Amendments to the Drawings:

REMARKS/ARGUMENTS

Fig 1

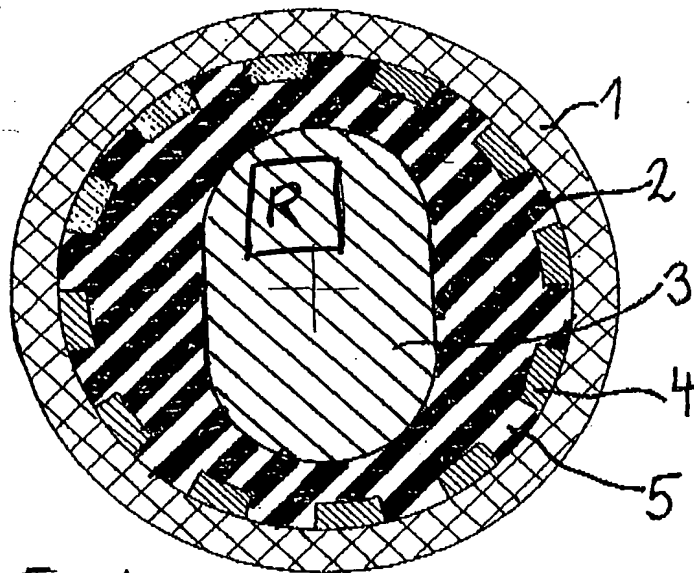
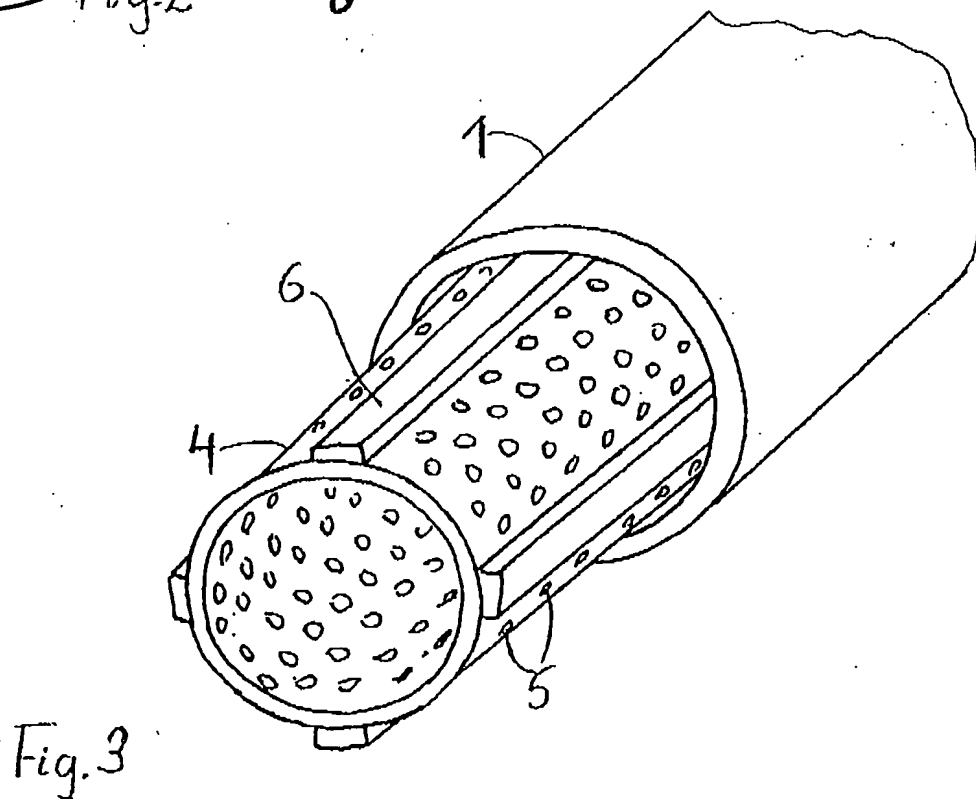
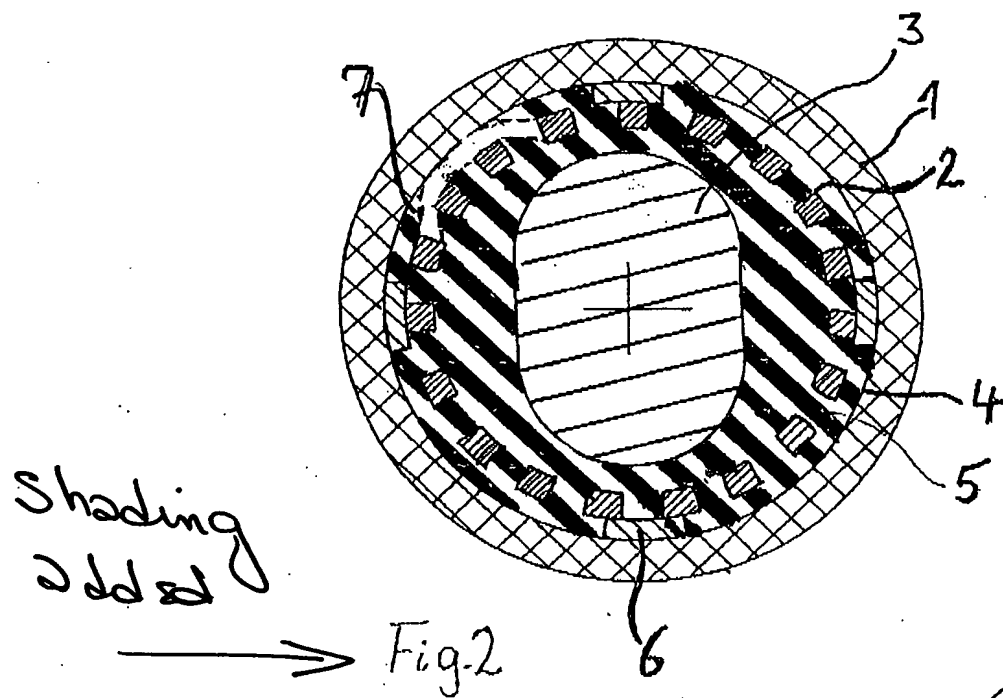
Furthermore, the rotor recited in claim 12, and discussed, for example, on page 6 of the specification, has now been indicated by the letter R in Fig. 1. In addition, the further apertures 10 in the outer tube 1 (of claim 21) have been illustrated in Figs. 8 and 9.

R added
shading added

Fig. 6

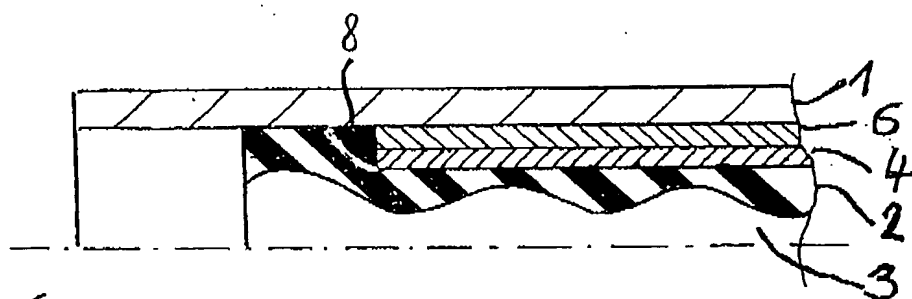
Shading
added

Fig. 7

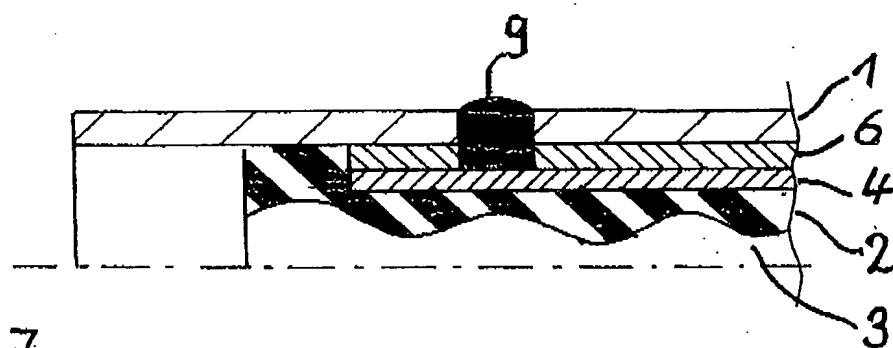
The attached sheets of drawings include changes to Figs. 1, 2, 6, 7, 8 and 9. These sheets replace the original sheets for these figures. Shading was added as required by the Examiner, the reference numeral 10 was added to Figs. 8 and 9, and the reference R was added to Fig. 1.

Fig. 8

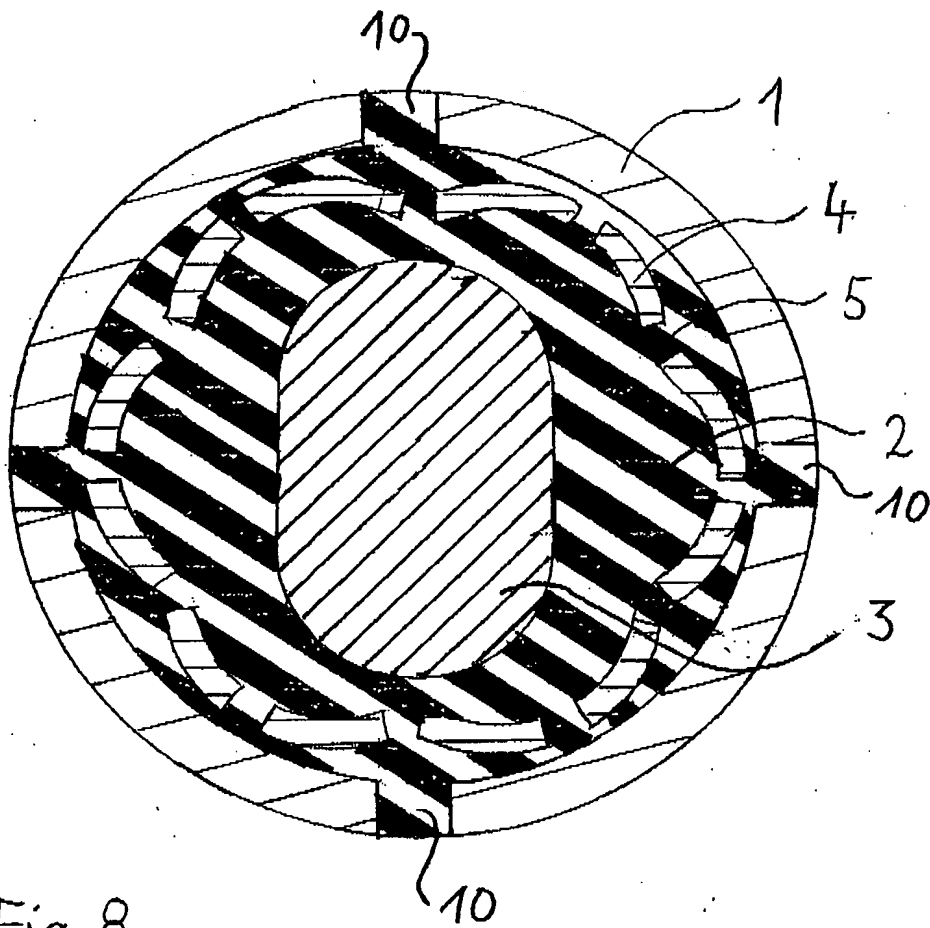
10 added
shading added

Fig. 9

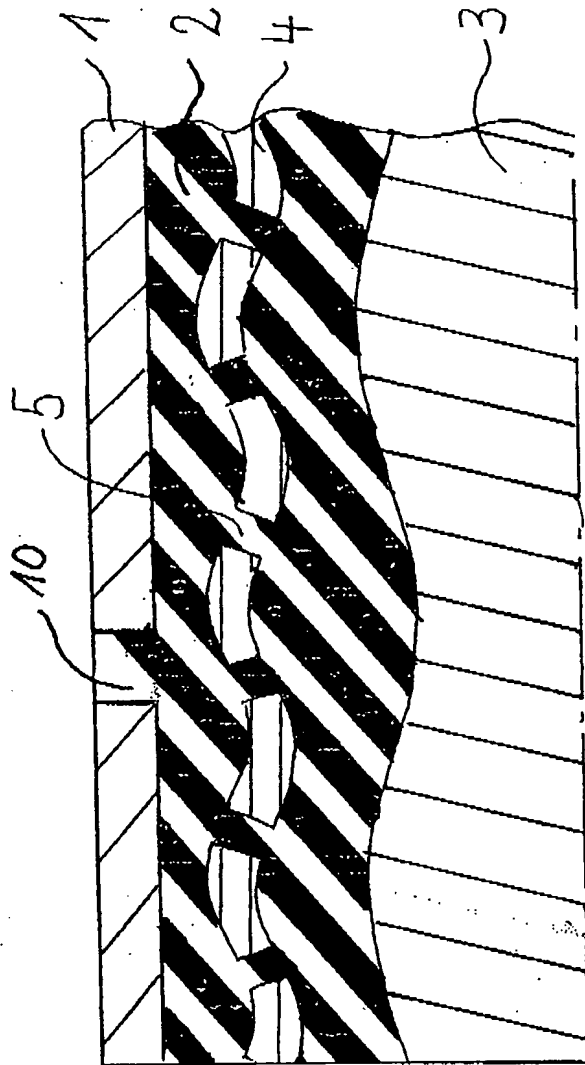
10 added
shading added
